Application for Licence Amendment

Licence Number	L8967/2016/1
Applicant	Roy Hill Infrastructure Pty Ltd
ACN	130 249 633
File Number	DER2016/000615-2
Premises	Roy Hill Port Bulk Handling Facility and Screening Plant Part of Lot 370 on Deposited Plan 35619 Certificate of Title Volume LR3118 Folio 753 Reserve 50892: Lots 1199, 1200 and 1301 on Deposited Plan 70562 Part of Lot 372 on Deposited Plan 35620 Certificate of Title Volume LR3118 Folio 755 within coordinates as defined in Schedule 1
Date of Report	11 December 2020
Status of Report	Final

Figure 3: Top 20 dust sources from the 60 Mtpa (base case) scenario

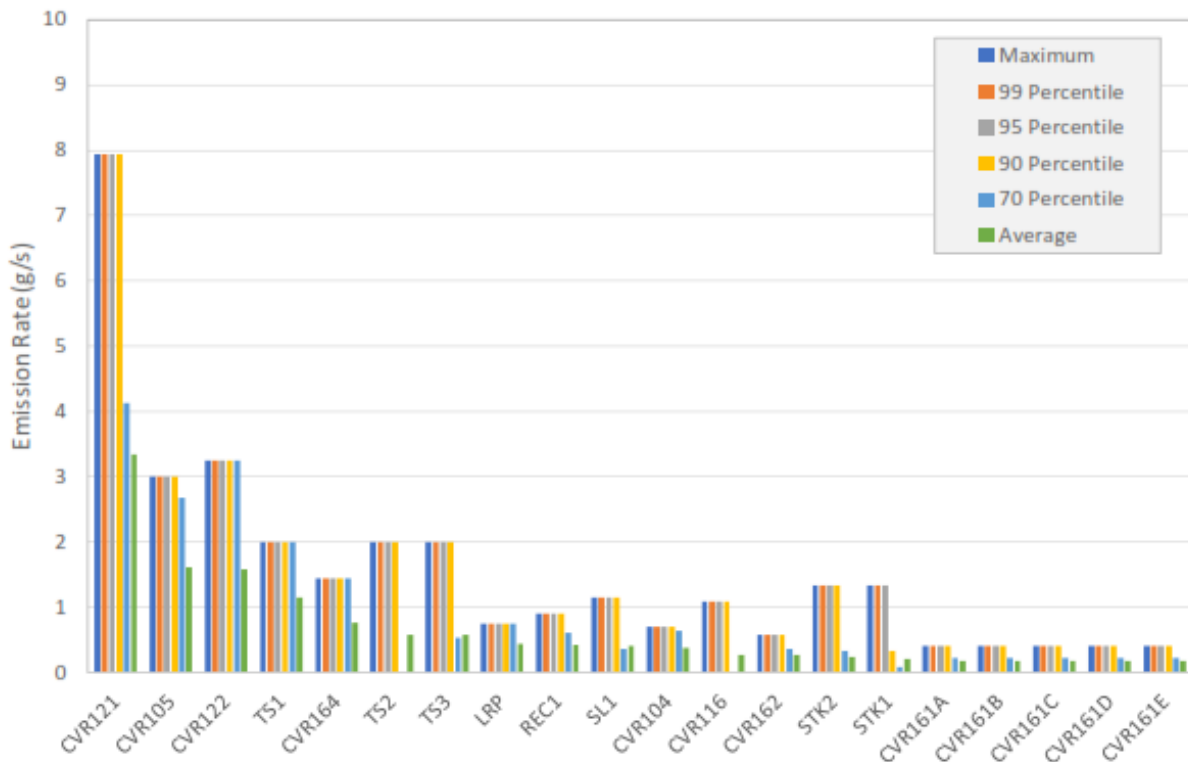
It is evident from emissions estimates used in the model that conveyor CVR121 emissions are significantly higher than other single emission sources for the unabated 70Mtpa scenario. There are large decreases in the 95th and 90th percentile emissions from CVR121, based on the installation of an additional belt wash station that has an availability rate of 90%.

Conveyors CVR121 and CVR122 were identified as having an average emission rate above the NPI controlled emission rate with recorded emissions being highly variable during the survey (refer to key findings in section 6.1.1). Prior to the survey, existing dust controls in the form of spray bars and conveyor skirts were upgraded. Monitoring data indicated that the effectiveness of these improvements was dependent on ore type with greater reductions in dust emission rates from CVR122 when handling lump ore (6.1g/s reduction) when compared with fines (2.8 g/s reduction).

Figure 5: Change in emissions for different sources between the 60 and 70 Mtpa scenarios

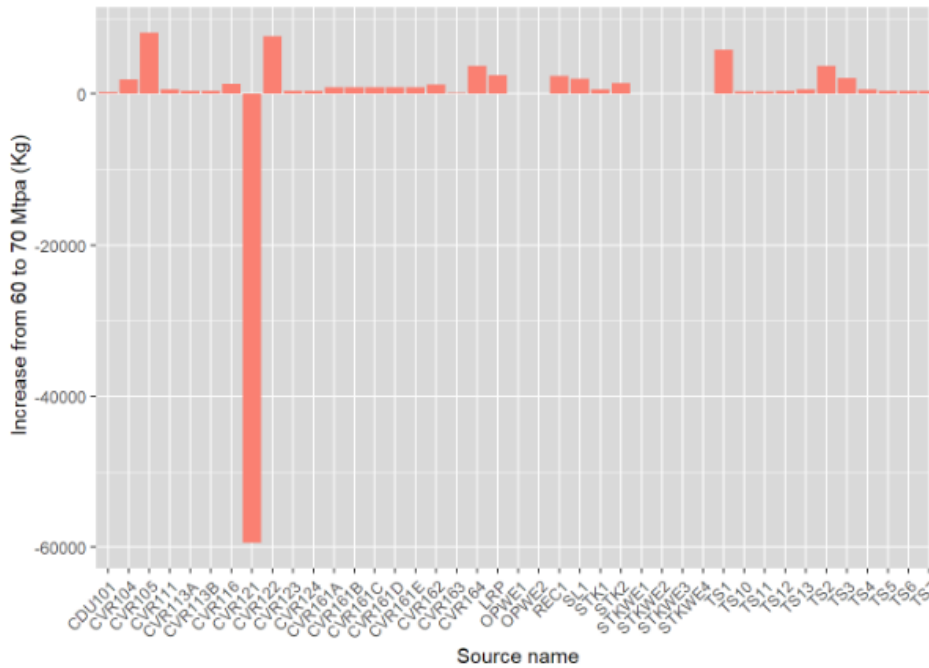
Figure 5 shows that most dust sources increase slightly in the annual emissions for the 70Mtpa scenario, with the exception of the two open areas and four stockpiles which show no change; and a very large decrease in emissions at conveyor CVR121.

Figure 7: Moisture content of fines ore against DEM (Application)

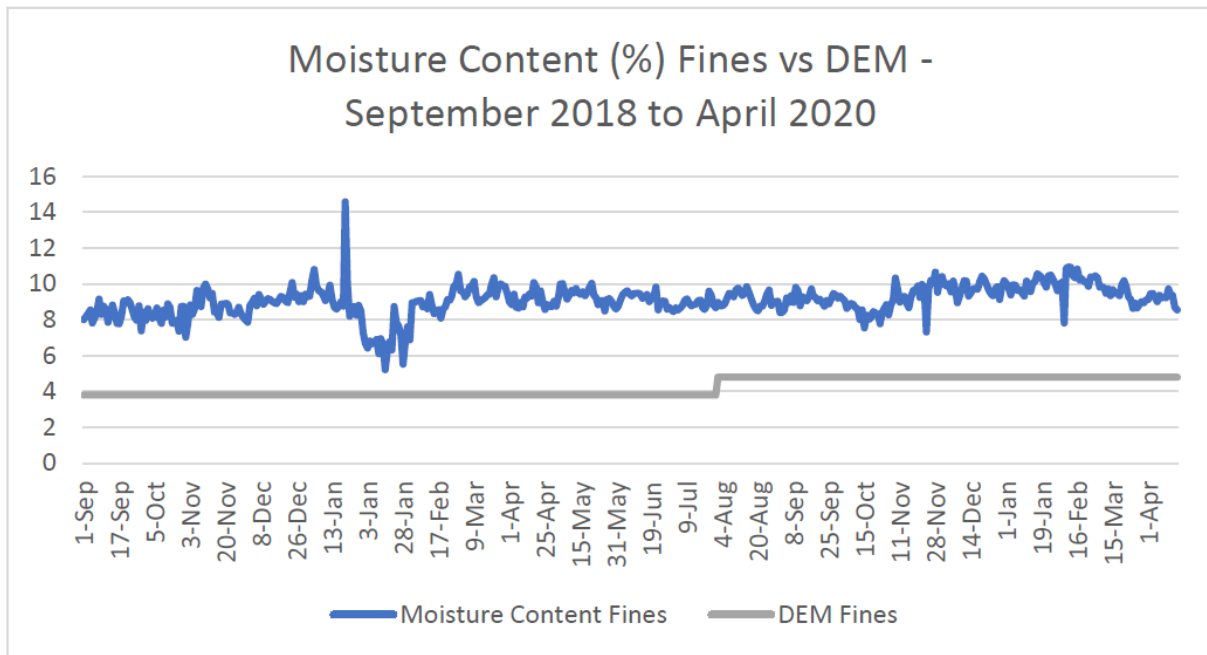
Figures 7 and 8 show that all ore received at, and outloaded from the Premises between September 2018 and April 2020 had a moisture content above the DEM level, based on online

While ore moisture remaining above DEM level is a key control for the management of dust emissions when handling and stockpiling iron ore, there remains the potential for dust emissions from the Premises. As discussed in section 8.1.1, ores handled at the Premises have a high friability, generating finer particles that have the potential to stick to conveyors. Product stuck to the underside of returning conveyor belts can then drop off and dry, presenting an alternate source of dust.

Figure 9: Areas for surface binding treatment (green area) and Stage 2 Trial rehabilitation (red striped area)

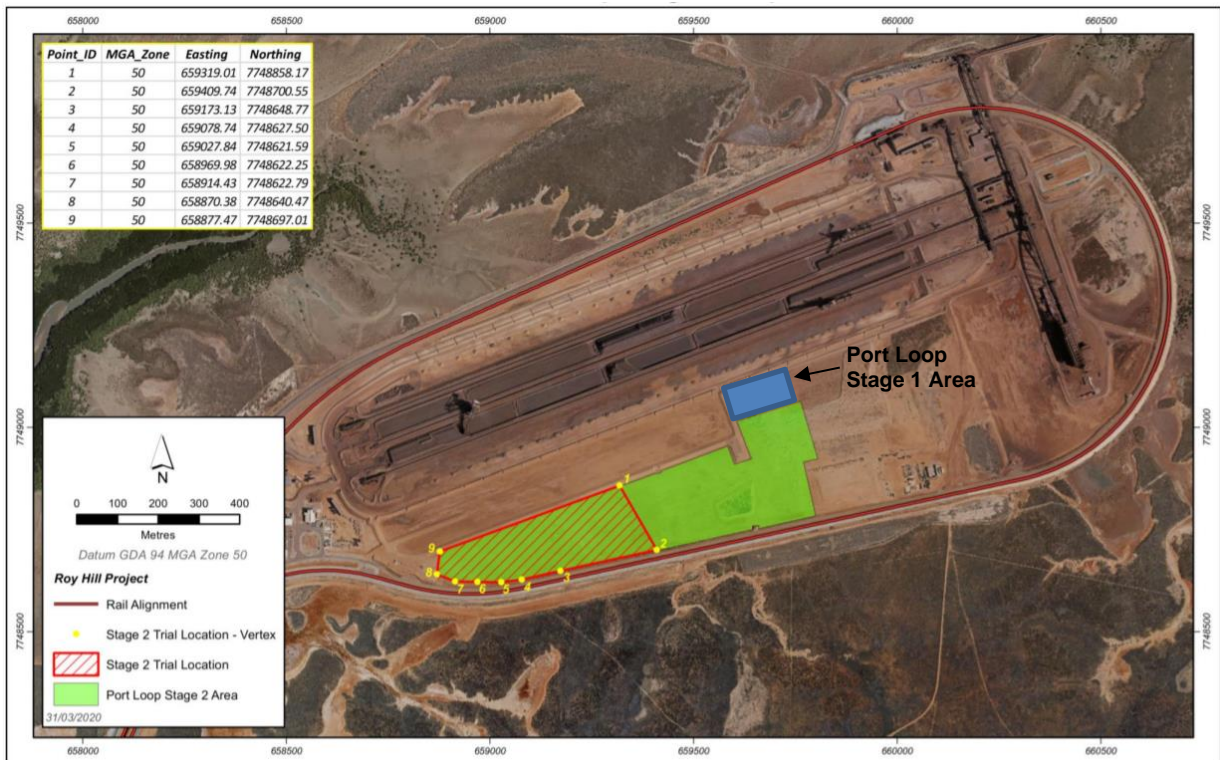
Following the failed trial in 2018/19, a further amendment was made to the Licence to allow for the application of a surface binding treatment to the larger Port Loop Stage 2 Area (Figure 9). The Licence Holder observed mixed results for surface binding treatments with good crusting over clay soils and poor binding over sandy areas. Fortnightly inspections of the binding treatment are conducted to ensure that dust from open areas is minimised.
